Application No.	Applicant(s)				
	10/723,126	GILBREATH, DONALD R.				
Office Action Summary	Examiner	Art Unit				
	Aaron M. Dunwoody	3679				
The MAILING DATE of this communication app	pears on the cover sheet with the c	correspondence address				
Period for Reply						
A SHORTENED STATUTORY PERIOD FOR REPL WHICHEVER IS LONGER, FROM THE MAILING D - Extensions of time may be available under the provisions of 37 CFR 1.1 after SIX (6) MONTHS from the mailing date of this communication. - If NO period for reply is specified above, the maximum statutory period is Failure to reply within the set or extended period for reply will, by statute Any reply received by the Office later than three months after the mailing earned patent term adjustment. See 37 CFR 1.704(b).	ATE OF THIS COMMUNICATION 36(a). In no event, however, may a reply be tinwill apply and will expire SIX (6) MONTHS from a cause the application to become ABANDONE	N. nely filed the mailing date of this communication. D (35 U.S.C. § 133).

DETAILED ACTION

Claims 1-5 are rejected under 35 U.S.C. 103(a) as being unpatentable over US patent 6318763, Huang in view of US patent 5709413, Salyers.

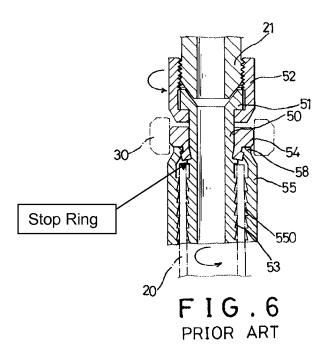
In regards to claims 1 and 2, Huang discloses an improved hydraulic fitting having a stem (50) including a hose insert portion (53), and a collar support portion, having a mating connection portion (50, 51), and a collar having (54), a torque communication portion, a female support portion, and an inner periphery extending

the collar support portion an axial stop ring (see Figure 6 below),

the torque communication portion of the collar staked in such a manner that the inner periphery extending through the torque communication portion communicates in a relatively non-rotational manner, and

the ferrule support portion of the collar staked in such a manner that the inner periphery extending through the ferrule support portion engages the axial stop ring in an axial movement limiting manner.

Applicant argues Huang does not disclose the ferrule support portion of the collar staked in such a manner that the inner periphery extending through the ferrule support portion engages the axial stop ring in an axial movement limiting manner. The Examiner disagrees. In Figure 6 above, Huang clearly illustrates the ferrule support portion of the collar staked in such a manner that the inner periphery extending through the ferrule support portion engages the axial stop ring in an axial movement limiting manner.
